ADDENDUM NO. 02
TO
SPECIFICATIONS AND CONTRACT DOCUMENTS
FOR
INVITATION TO BID
SSA JACKSONVILLE CONTAINER TERMINAL
PHASE 8
JPA CONTRACT NO. C-1772A

JPA CONTRACT NO.: C-1772A SSA JACKSONVILLE CONTAINER TERMINAL – PHASE 8

UTILITY PLAN
SHEET 3 OF 3

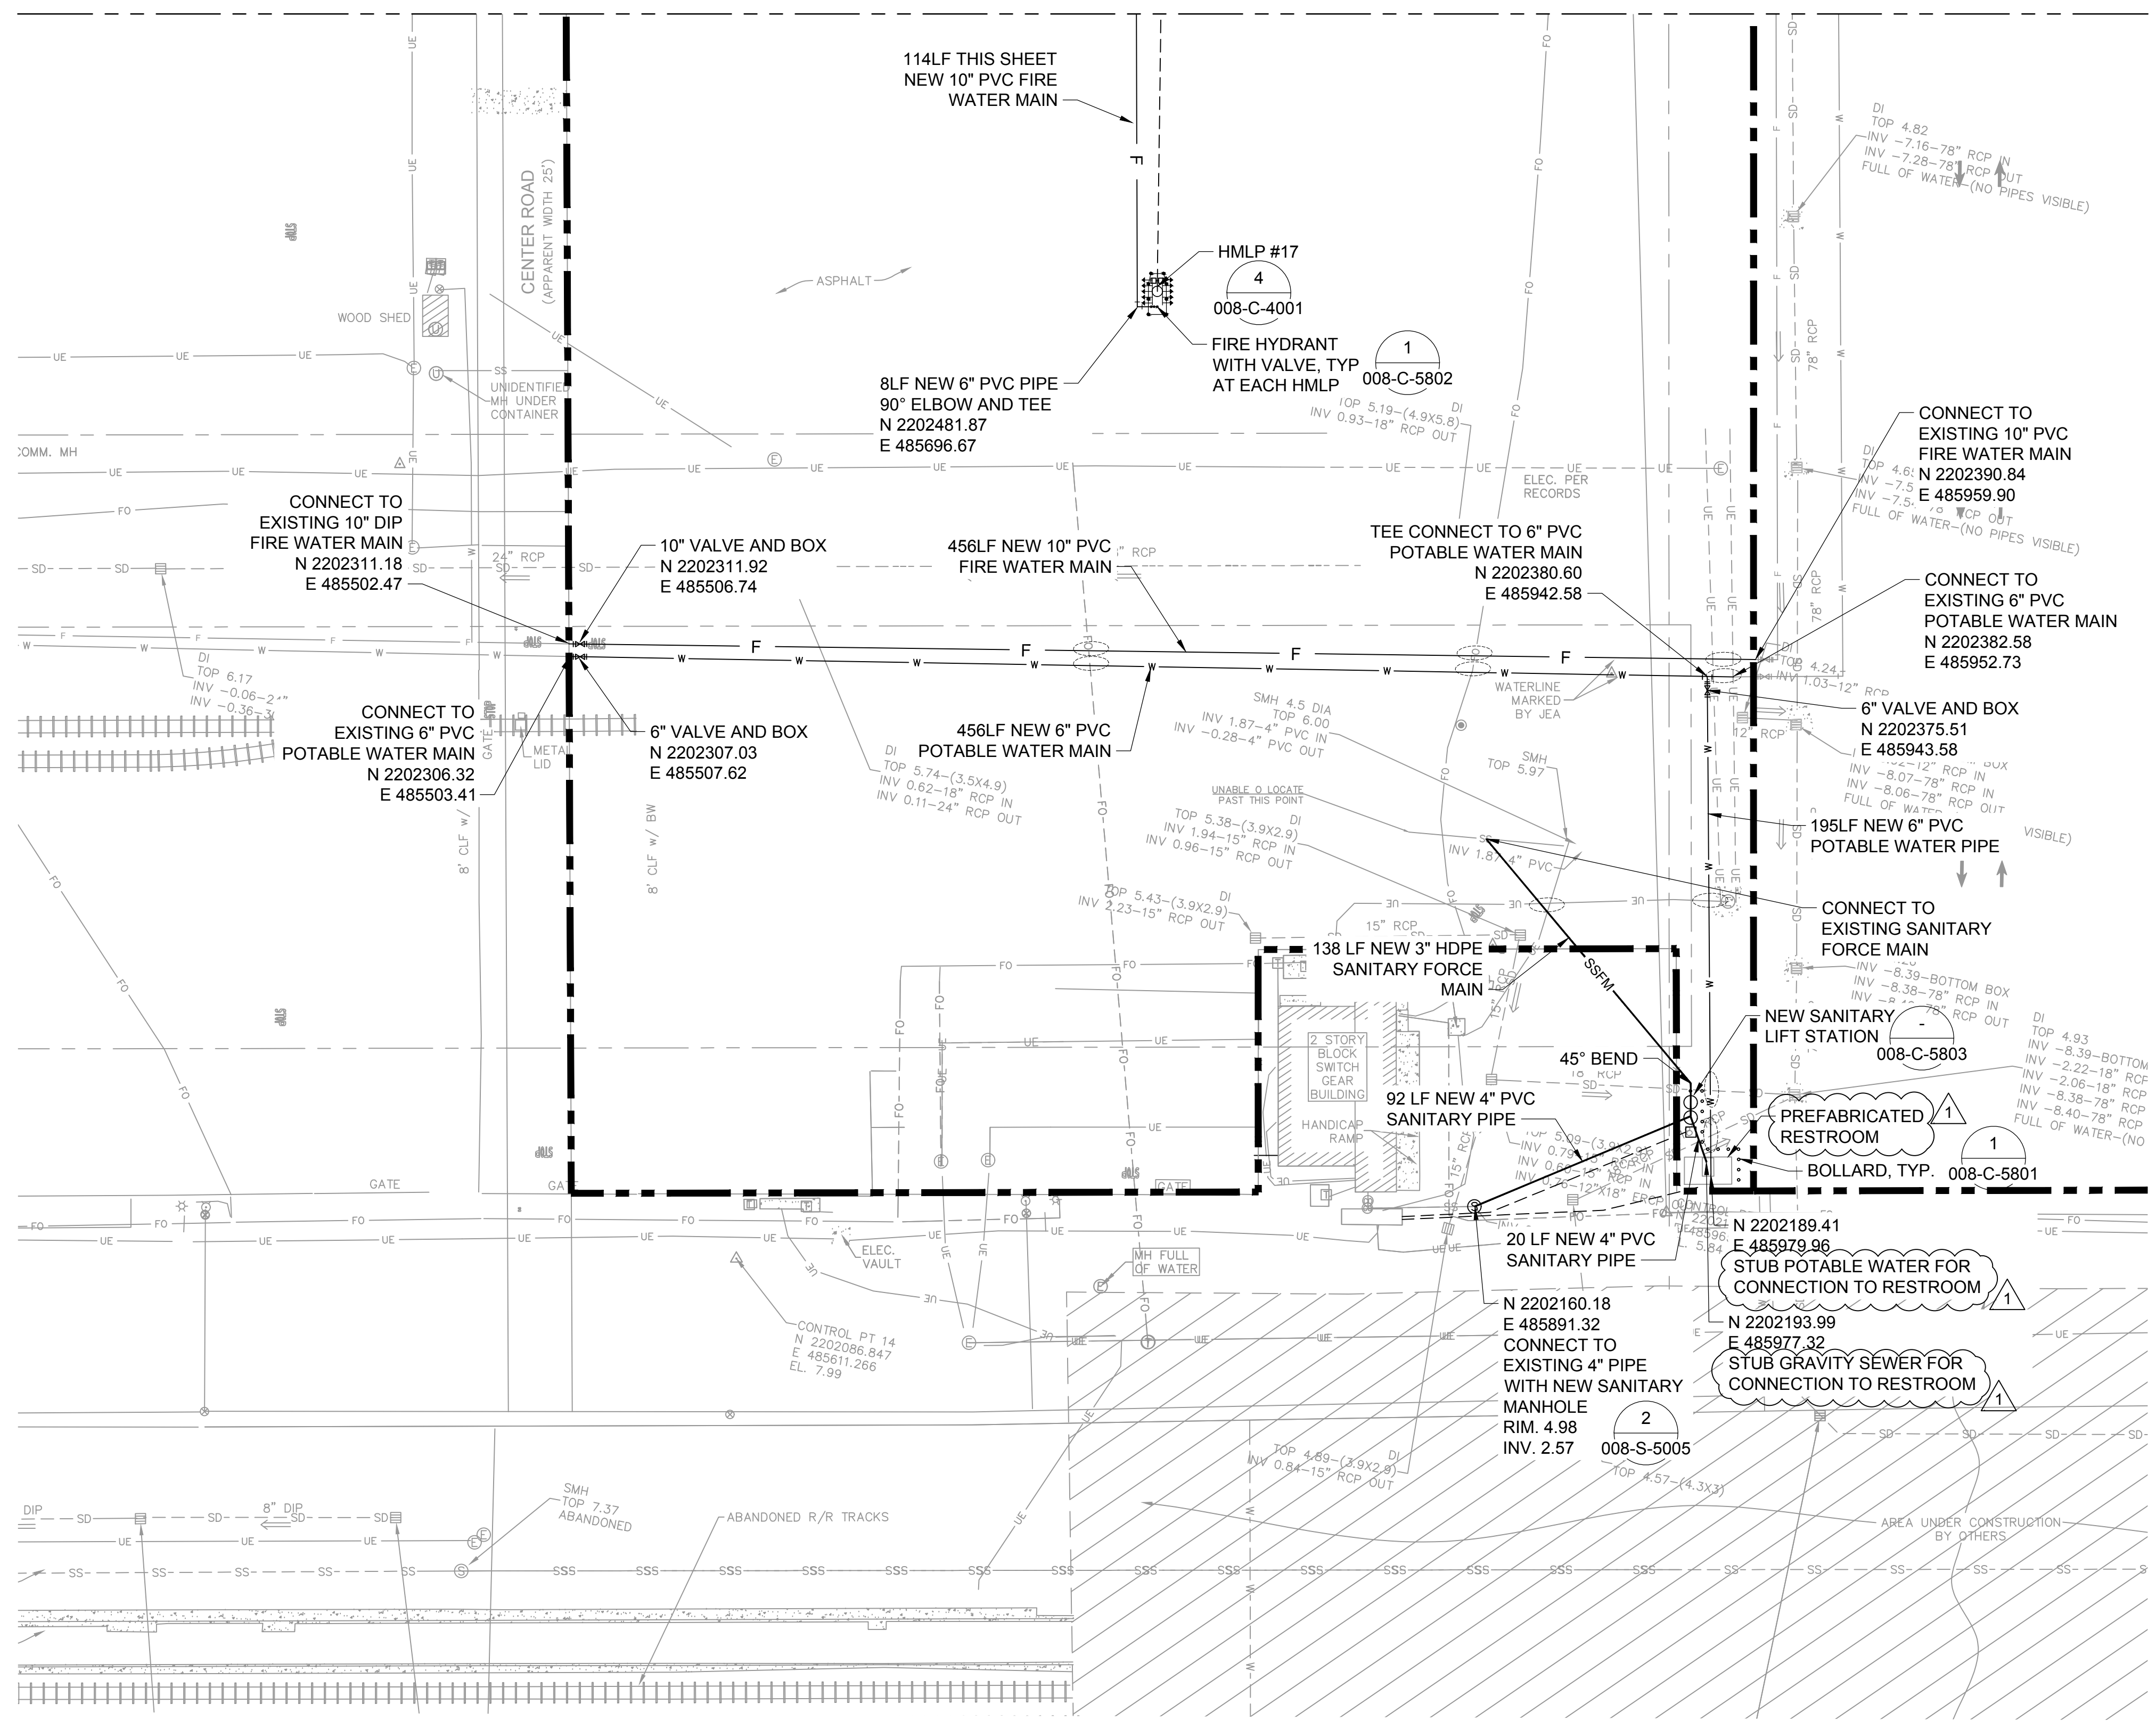
5. The bid form has an item for furnishing and installing a prefabricated restroom. The plans say by others. If we are to provide, please include a specification in the next addendum.

ANSWER: Please see attached Drawing 008-C-2803-Rev1 where the note "by others" has been removed. The prefabricated restroom is to be supplied and installed by the Contractor. Reference H in Bid Documents provides information regarding proposed prefabricated restroom, including floorplan and a quote from the manufacturer. Bidder shall obtain own quotes for bid. Equivalent or similar floorplans and manufacturers will be accepted, but adjustments to civil works to accommodate alternate restroom configuration shall be at Contractor's cost.
